<b>CITY OF WESTMINSTER</b>			
<b>PLANNING APPLICATIONS SUB COMMITTEE</b>	<b>Date</b> 16 April 2019	<b>Classification</b> For General Release	
<b>Report of</b> Executive Director Growth Planning and Housing		<b>Ward(s) involved</b> Marylebone High Street	
<b>Subject of Report</b>	<b>5 Spanish Place, London, W1U 3HZ</b>		
<b>Proposal</b>	Erection of a rear two storey extension at lower ground and ground floor level in order to enlarge dwellinghouse (Class C3), excavation under pavement vaults, relocation of air conditioning units within an acoustic enclosure at roof level, addition of a roof hatch to provide access to a sunken roof terrace, erection of a pergola at rear first floor level, internal alterations and general refurbishment works.		
<b>Agent</b>	Neil Wilson Architects Limited		
<b>On behalf of</b>	Mr Andrew Clark		
<b>Registered Number</b>	18/08517/FULL 18/08518/LBC	<b>Date amended/ completed</b>	10 October 2018

**Address:** 5 Spanish Place, London, W1U 3HZ,

**Proposal:** Erection of a rear two storey extension at lower ground and ground floor level in order to enlarge dwellinghouse (Class C3), excavation under pavement vaults, relocation of air conditioning units within

**Proposed Roof Plan**

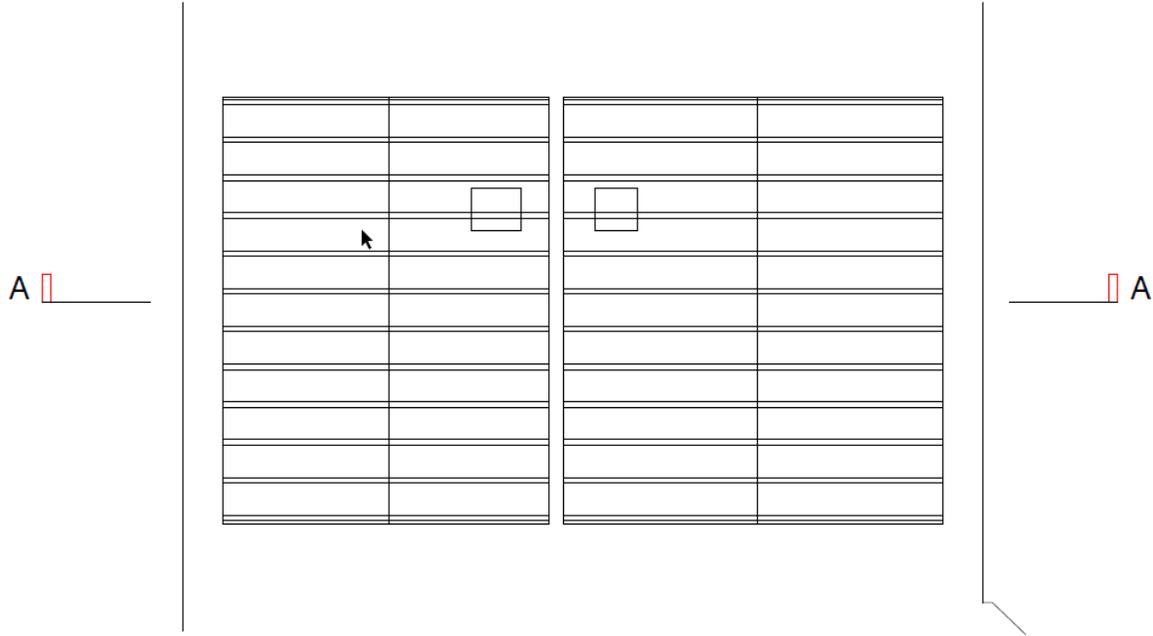
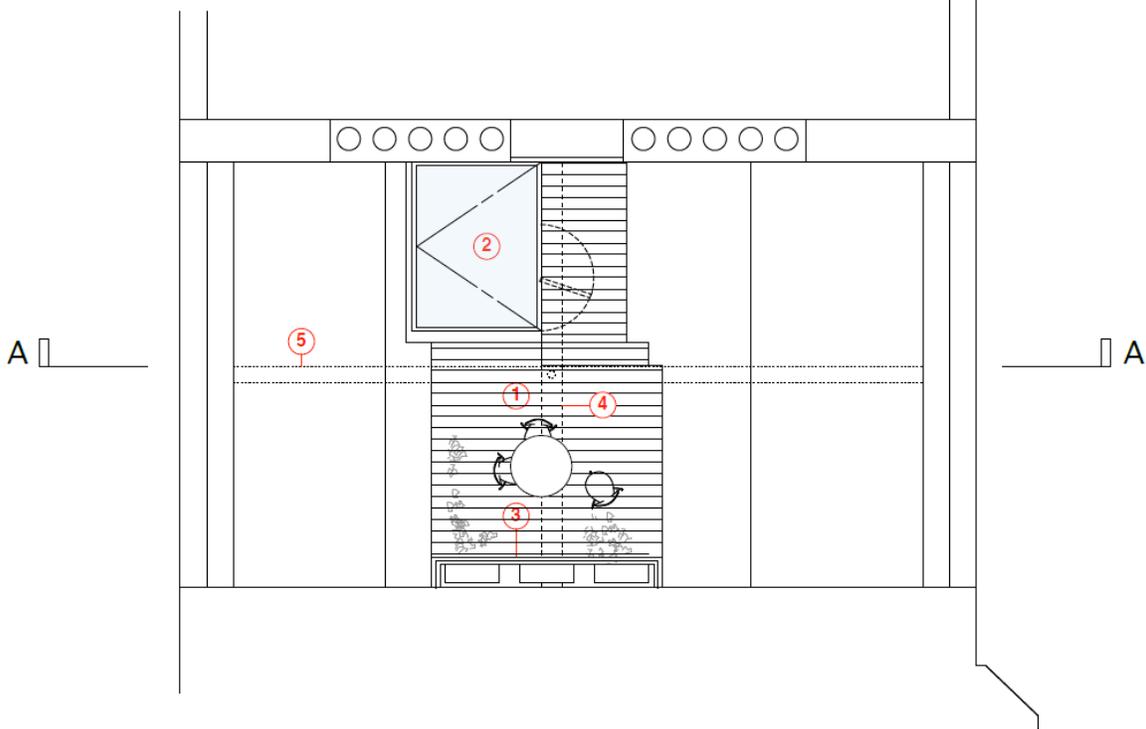
At roof level, it is proposed to relocate the air conditioning plant to an area adjacent to the high gable end of the neighbouring Spanish Mansions to provide space between the roof slopes for a decked area to be installed for use as a rooftop terrace. In order to gain access to roof, it is proposed to install a new glazed opening.

The original M-shaped Georgian roof survives. A terrace will be created in the valley between the front and rear roofs, with a small access hatch and plant area. These works will have minimal impact on the appearance and fabric of the roof and are acceptable.

The proposed rooftop terrace would be set well within the roof area and away from its edges ensuring that there would be no overlooking of neighbouring properties from this feature.

There has been an objection from the neighbouring Spanish Place Mansions on the grounds that the proposed roof terrace would be a source of noise and light pollution for the adjoining occupiers. The Marylebone Association also comment that light pollution from the glazed extension may be an issue. However, the terrace would be modest in size, being just large enough to accommodate a patio table and chairs, and therefore it is considered that it would be a low intensity use unlikely to cause significant disturbance to others. Roof terraces are familiar features in this type of urban setting and provide welcome external amenity space for residents.

Objections have been received from some residents at Spanish Place Mansions concerning the proposed relocation of the rooftop air conditioning units to a position

closer to the gable end of that mansion block. The objectors consider that these would be a potential source of disturbance, including the possibility of noise and vibration travelling through to the fabric of the neighbouring mansion block. At officers request the original submissions have been amended so that the units are now proposed to be set slightly away from the neighbouring property rather than attached to it to prevent that from happening. The standard vibration condition is also imposed.

Objections have also been received on the grounds that the proposed new roof terrace would cause a significant fire hazard to the site and neighbouring properties (as a result of leaf litter, cigarette ends etc. falling below the timber) which would be exacerbated by “explosive” air conditioning units located on the boundary wall. It is not considered that such issues fall within the planning process and would more likely be an issue covered under building control regulations. Furthermore, such elements are a common feature at properties through central London. It would be unreasonable to withhold planning permission on such grounds and therefore the comments cannot be upheld.

The submissions also include a noise report to demonstrate that the air conditioning units would not be audible at any neighbouring residential window. One objector is concerned that the report is inaccurate and out of date. However, the report has been assessed by Environmental Health officers who are satisfied that, subject to the submission of a post-commissioning noise report, the proposed plant would comply with UDP policy ENV7 concerning noise limitations, and that the Council's standard noise condition would be complied with.

- 7 You must put up the plant screen shown on the approved drawings before you use the machinery. You must then maintain it in the form shown for as long as the machinery remains in place. (C13DA)
